PIERGIORGIO BERUTO

IEEE 802.3cg
Clause 148 cleanup
September 9th, 2019

#1: BEACON is not sent (fix)

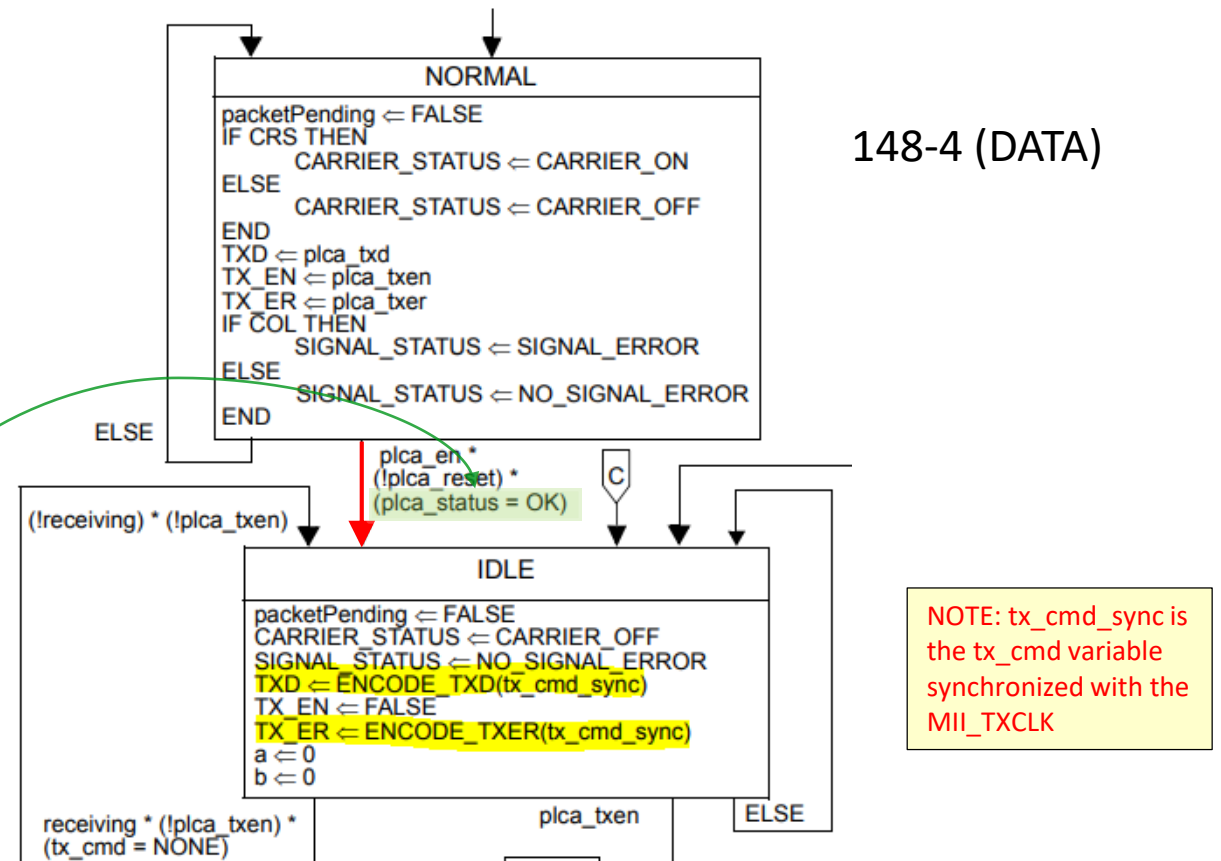
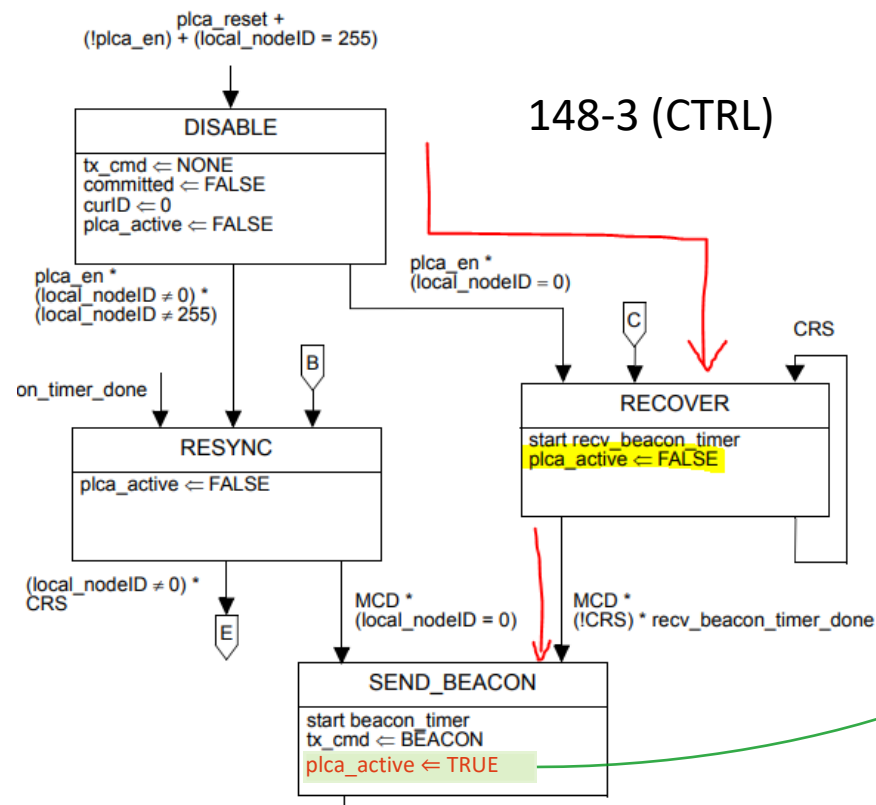
#1: BEACON is not sent

- When PLCA is disabled, `plca_status` is not OK
 - The PLCA Data State Diagram is held in NORMAL state
 - in NORMAL state the MII signals are driven by the MAC directly (normal CSMA/CD w/o PLCA). They cannot convey BEACON or COMMIT requests to the PHY.
- When PLCA is enabled for the first time, the node with $ID = 0$ sends a BEACON, as described in the PLCA Control State Diagram
 - since `plca_active` is FALSE, the DATA State Diagram remains in NORMAL state and does not send the BEACON

The simple fix is to set `plca_active` TRUE in `SEND_BEACON` state

This makes the DATA State Diagram progress to IDLE state, where the BEACON is conveyed as intended

#2: packets not sent in burst mode

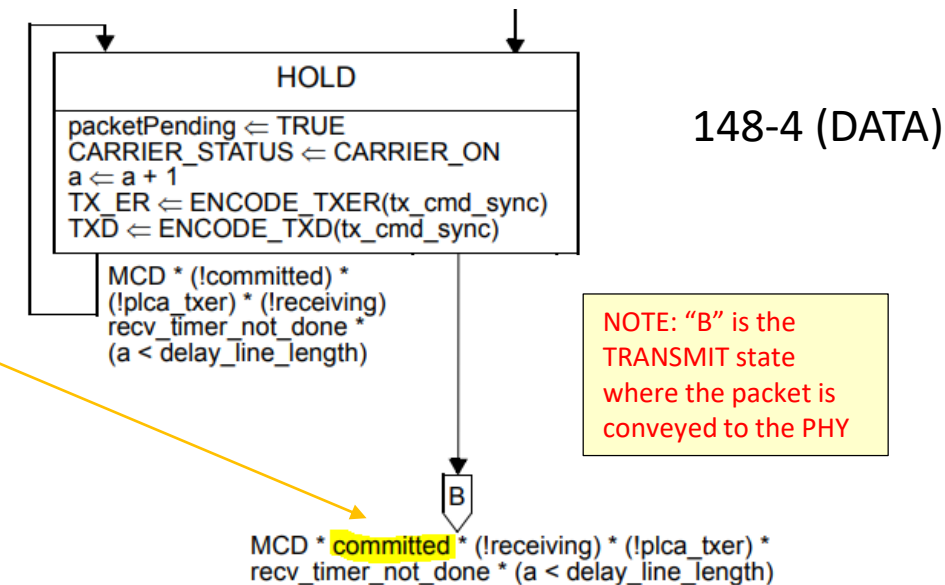
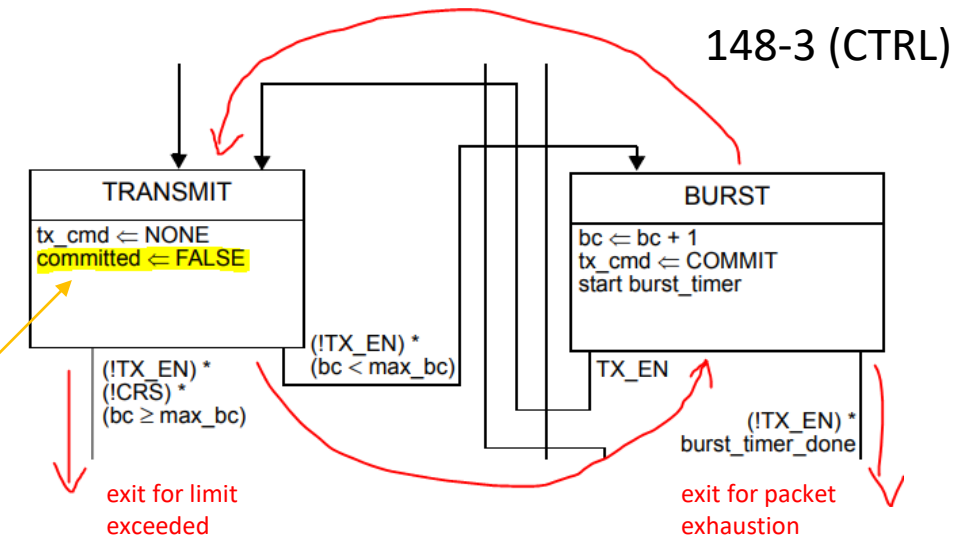
- When burst mode is enabled ($\text{max_bc} > 0$) the PLCA Control State Diagram loops between TRANSMIT and BURST states until the MAC has no more packets available to send, or the configured burst limit is reached.

— Note that the “committed” variable is set to FALSE

- The DATA State diagram, however, requires the “committed” variable set to TRUE to progress to the TRANSMIT state.

#3: fake collisions during burst (1)

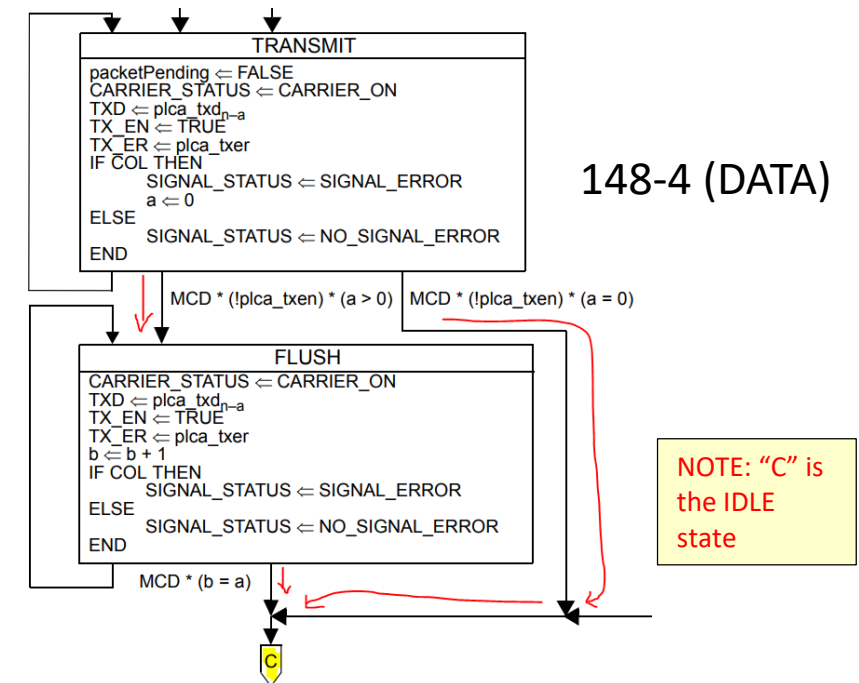
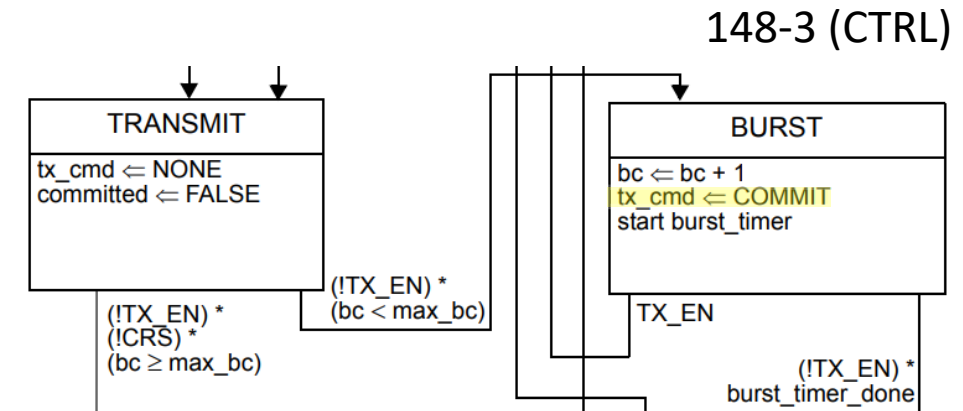
- During a burst, the IPG is filled by COMMIT (IDLE symbols) to keep the transmit opportunity. See http://www.ieee802.org/3/cg/public/Nov2018/buruto_3cg_PLCA_burst_mode_revB%20.pdf.
- This is done by setting `tx_cmd = COMMIT` while the Control Sdtate Diagram is in the BURST state.
- After the first packet is sent, the DATA State diagram moves from TRANSMIT/FLUSH to IDLE state. This happens as soon as the delay line is empty and the MAC is done sending data.

148-4 (DATA)

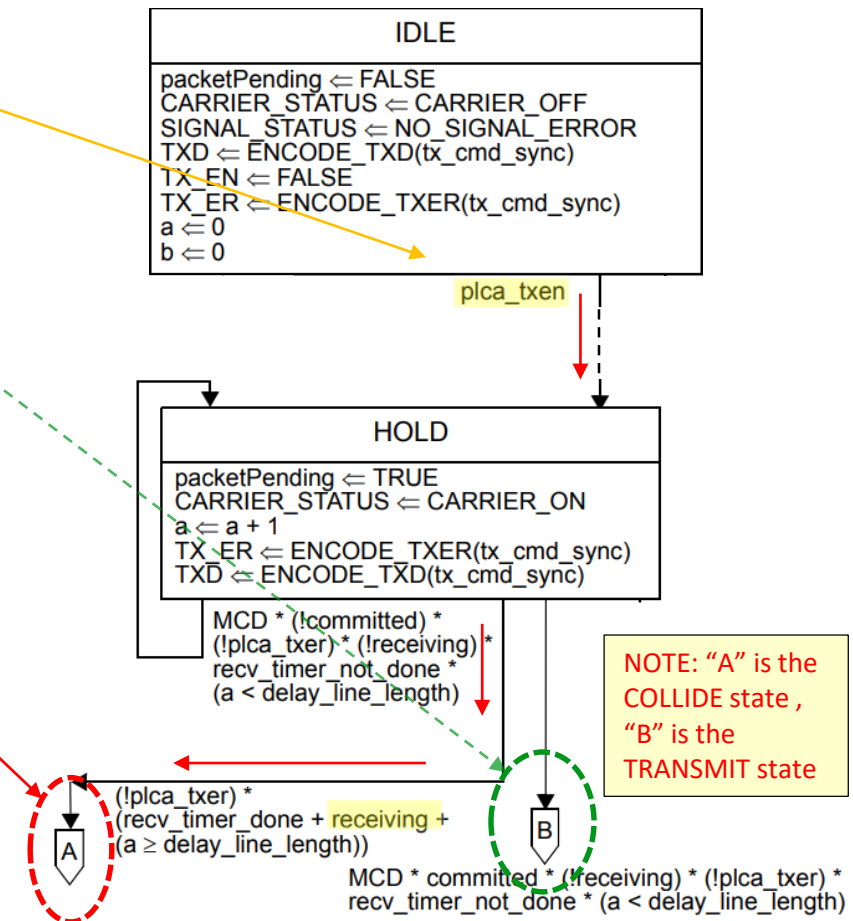
- The DATA state diagram from IDLE will move to HOLD as soon as the MAC transmits the next packet.
- From HOLD state the DATA State Diagram is supposed to progress to the TRANSMIT state to have the PHY sending the packet on the line.
- However, depending on the PHY RX latency, the “receiving” variable *maybe* TRUE at that time because of the COMMIT request being looped back into a COMMIT indication
 - This would make the DATA State Diagram report a false collision to the MAC.

#4 MII setup/hold times violation

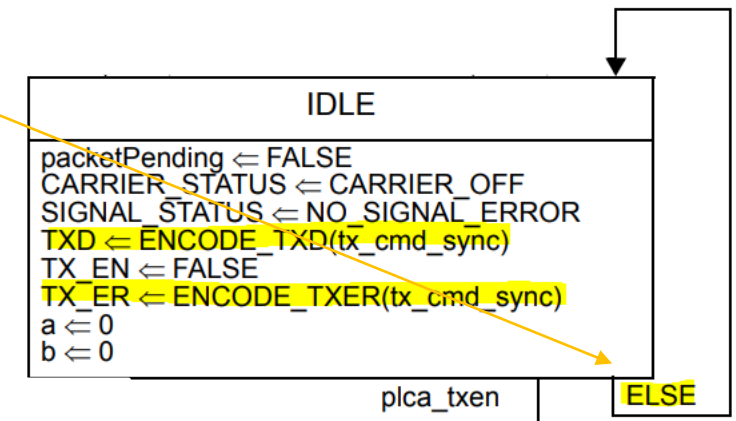
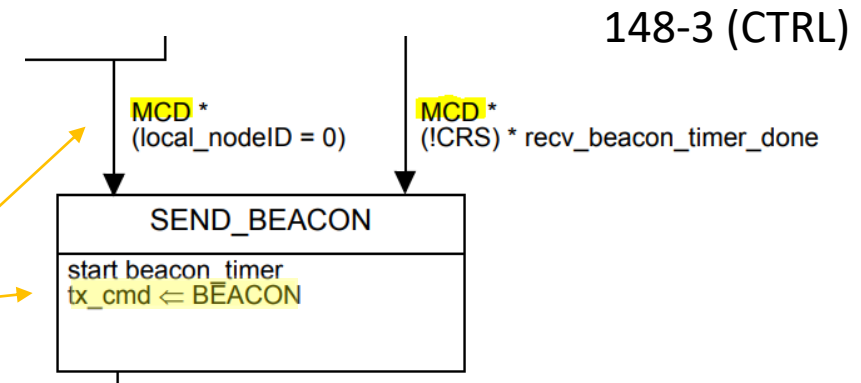
- According to Clause 22.3.1 the MII signals going from the RS to the PHY (TXD, TX_EN, TX_ER) shall be output from 0 to 25ns after the rising edge of TX_CLK.
- The SEND_BEACON state in the Control State Diagram is entered on the rising edge of TX_CLK (MCD), and the tx_cmd variable is set accordingly.
- The DATA State Diagram, which drives the MII signals, refreshes itself when the tx_cmd_sync variable changes.
- The tx_cmd_sync variable is defined as the sampling of tx_cmd on the **falling** edge of the MII TX_CLK.
- Since the TX_CLK clock period for 10 Mb/s is 400ns, this refresh may occur 200 ns later than the rising edge, which violates the requirement in 22.3.1 (see first bullet).

#5 non-PLCA nodes preventing PLCA from starting (1)

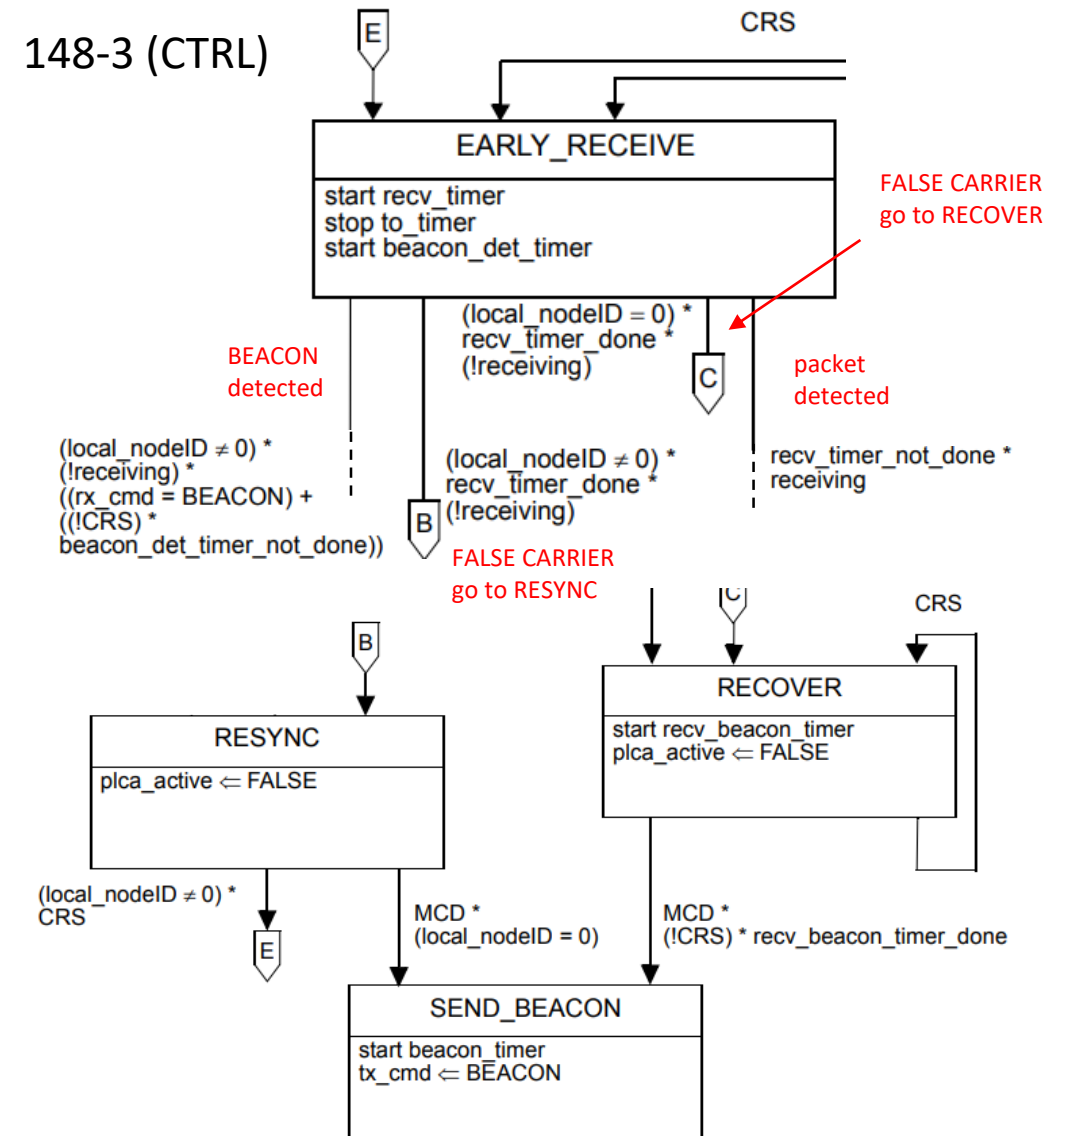
- PLCA features a “recovery” mechanism that makes a node skip its TO in case the internal TO counter is possibly misaligned.
 - This may happen when a false carrier event (e.g. impulsive noise) occurs on the line. In such situation each PHY on the network *may* assert CRS (which is involved in the counting of the TOs) for a different duration.

- This is captured by the PLCA CONTROL State Daigram by the means of the EARLY_RECEIVE, RESYNC and RECOVER states
- The idea is that when a CRS event is not followed by the reception of a packet within rcv_timer duration (i.e. the PHY could not decode the data), the node goes either in RECOVER or RESYNC state depending on whether it is the one in charge for sending the BEACON (`local_nodeID = 0`) or not.

- In RESYNC state a node waits for a new BEACON before getting a new TO
 - In RECOVER state (`local_nodeID = 0`) the node waits for the line to be quiet (`CRS = FALSE`) for a certain amount of time before sending a new BEACON

#5 non-PLCA nodes preventing PLCA from starting (2)

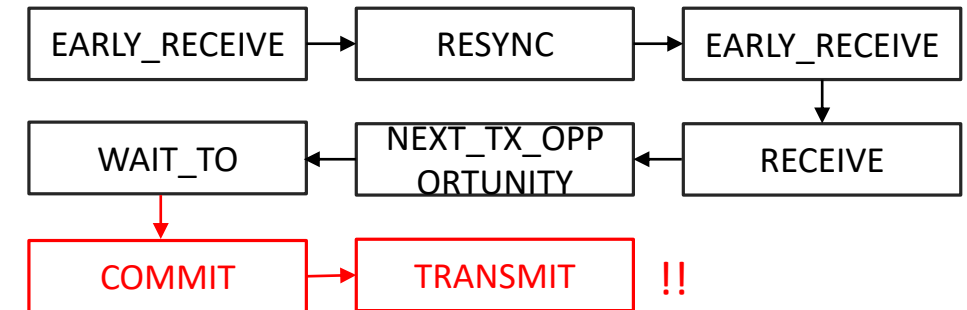
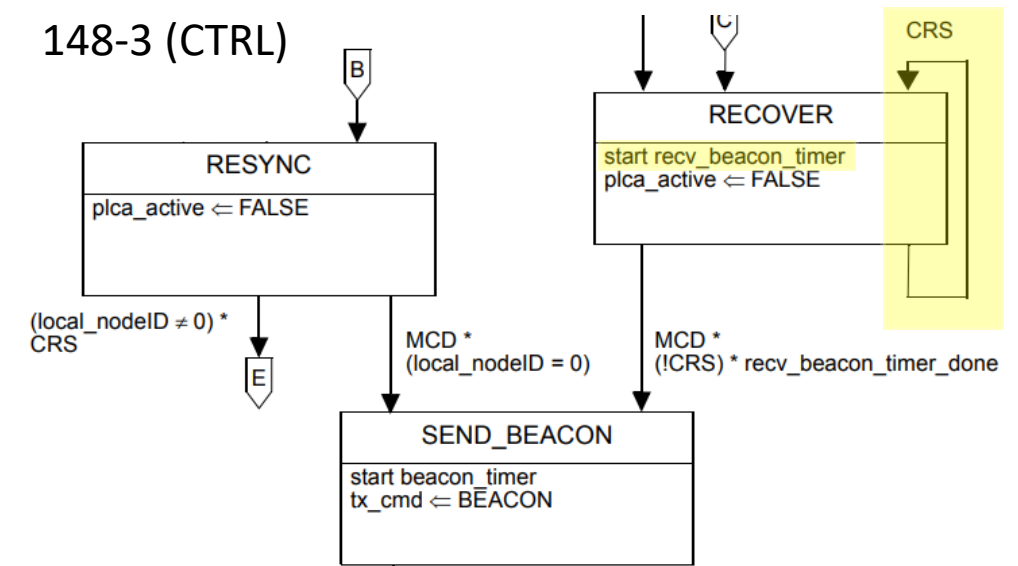
- In the **very unlikely** case where non-PLCA enabled nodes are sending packets at a rate which is higher than the `recv_beacon_timer` frequency, the node in charge of sending the BEACON **may never reach the SEND_BEACON state**.
- Additionally, the BEACON may be sent when CRS is asserted, resulting in a collision on the line (performance loss)
- Finally, a node detecting a false carrier (`recv_timer` expired) *may* receive a packet (go to RECEIVE state) and get a new TO even if a *new* BEACON has not been received first (i.e. `curlD` may be out of sync).
 - This may create a collision (perf. loss)
 - It may also create a false BEACON detection (perf. loss)

Fixes to Fig. 148-3 (PLCA Control State Diagram)

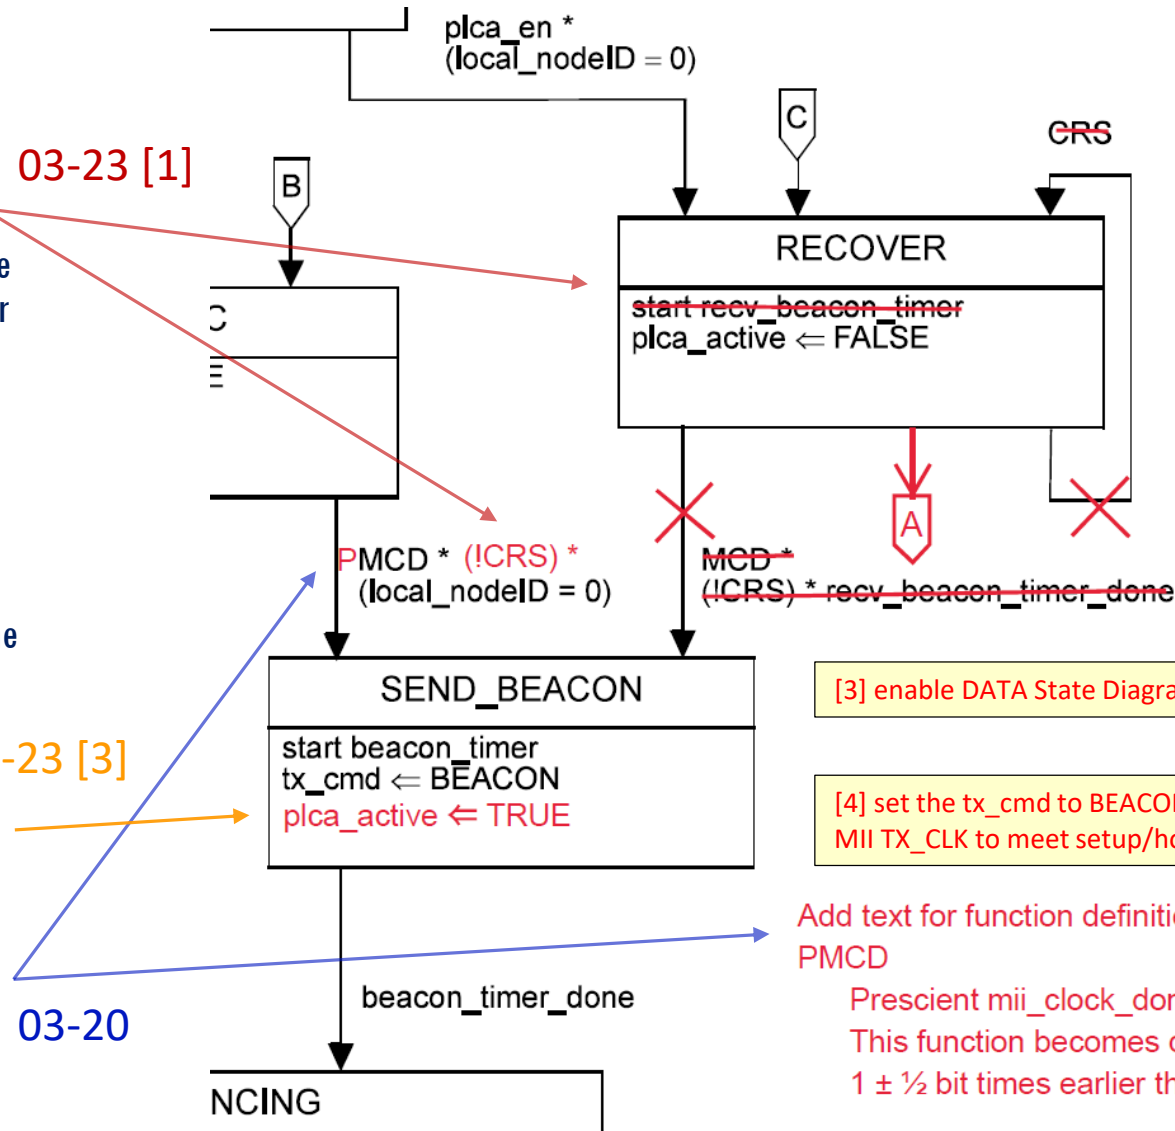
[1] The node with `local_nodeID = 0` may not be able to send a BEACON in the unlikely situation that non-PLCA enabled nodes keep sending packets at a rate higher than the `recv_beacon_timer` expiration. In such case the PLCA Control State diagram would be stuck in the recover state.

[2] The Control state diagram may loop from EARLY_RECEIVE and RESYNC state because of CRS being continuously asserted. This may cause a false detection of the BEACON if the `recv_timer` elapses when `CRS=TRUE` at the end of a packet where the length of the CRS is compatible with the length of a BEACON.

[3] The BEACON may not be sent when PLCA is first enabled due to the Data state diagram being in normal state with `plca_status = FAIL`, preventing this one to become OK.

[4] Achieve proper synchronization with MII TX_CLK in the PLCA Data State Diagram

[1] The idea is that node with ID = 0 goes through a cycle of TOs with `plca_active = FALSE` before sending a BEACON. This prevents it from sending data during this cycle and allows other nodes to complete the previous cycle undisturbed. The CRS is further tested before sending the BEACON to reduce the chance of collisions in presence of non-PLCA enabled nodes.

[3] enable DATA State Diagram when BEACON is being sent

[4] set the `tx_cmd` to BEACON just before the posedge of the MII TX_CLK to meet setup/hold requirement.

Prescient `mii_clock_done` function.
This function becomes done exactly $1 \pm \frac{1}{2}$ bit times earlier than `mii_clock_done`
